## Product Change Notification / SYST-07KIRV017

ERRATA - PIC32MK General Purpose and Motor Control (GP/MC) Family Silicon Errata and Data Sheet Clarification Errata Document Revision

**Description of Change:** • 59. (Flash - RTSP)

## PIC32MK General Purpose and Motor Control (GP/MC) Silicon Errata and Data Sheet Clarification

**FIGURE 1: Posc CRYSTAL CIRCUIT**

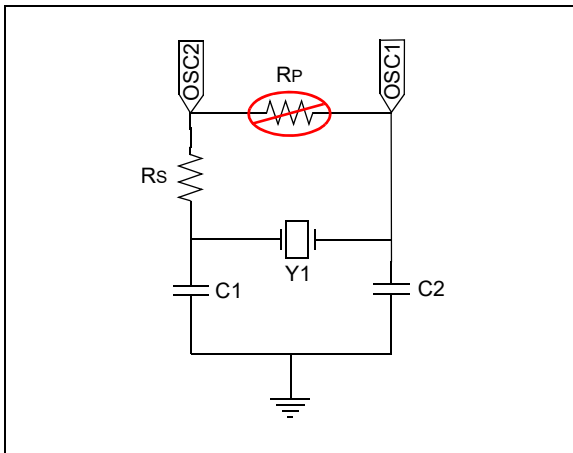
The Posc supports only specific crystal operation, as provided in [Table 1](#).

The Primary Oscillator (Posc) has been characterized to operate at 8 MHz and 12 MHz when the circuit shown in [Figure 1](#) is implemented and the operating conditions provided in [Table 1](#) are met.

**FIGURE 2: RESET SUPERVISOR CIRCUIT**

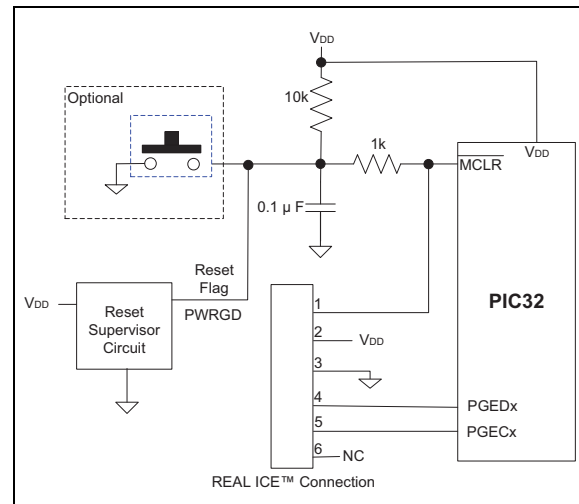
On a BOR event,  $V_{POR} < V_{DD} < V_{BOR}$ , a Reset is not generated when the BOR threshold is reached. System clocks will stop with all I/O pins functions frozen in their present state until either  $V_{DD}$  falls to  $V_{POR}$  or  $V_{DD}$  returns to above  $V_{BOR}$ . The user must assess if this  $V_{DD}$  brown-out condition and the resulting frozen I/O pin state has an adverse effect on their application (UART, PWM, I/O, OC, etc.).

Use an external Reset supervisor/monitor (see Figure 2). Some LDO regulators, as listed in Table 4, have an embedded reset supervisor included. The required minimum reset trip voltage of the supervisor should be at least ( $V_{BOR} + 0.5V$ ) with the SMCLR bit (DEVCFG0<15>) = 0 and the BORSEL bit (DEVCFG2<29>) = 1 in the Configuration Words. This means that the minimum  $V_{DD}$  operating voltage of the application needs to be above the reset supervisor maximum trip voltage at [Reset Trip (max) + 0.2V], (i.e. Application  $V_{DD(MIN)} = \sim(V_{BOR} + 0.5V + 0.2V)$ ). The reset supervisor should have an open drain output so as not to interfere with the MPLAB
